**SERVICE BULLETIN:
IBV, FBV, FV, TWV**

MODELS: IBV, FBV, FV and TWV

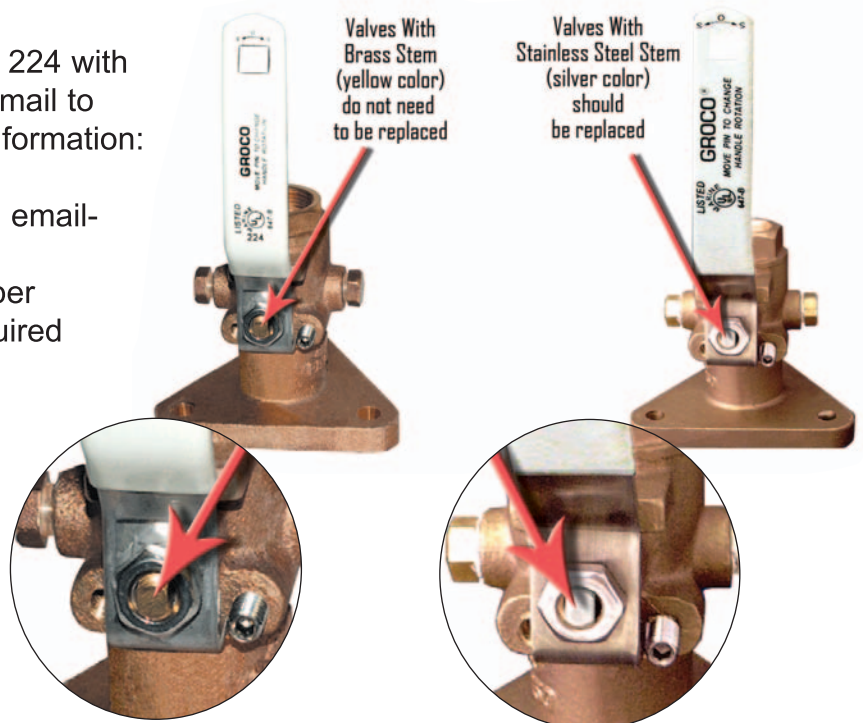
GROCO's design for the imported valves series shown above specified a high-grade stainless steel valve stem. We have discovered that the stem material used in some of the valves manufactured between 2004 and 2006 may not have complied with our specifications. Valves with out-of-spec stems may not be suitable for salt-water use. Since the non-compliant silver color stems may fail when the valve is actuated we wish to have all such valves removed from service. GROCO will supply replacement valves at no charge.

Visually inspect the valve(s) on your boat. If the valve has a stainless steel stem (silver color), the valve should be replaced during the next scheduled haul-out. Valves with a brass stem (yellow color) require no further action.
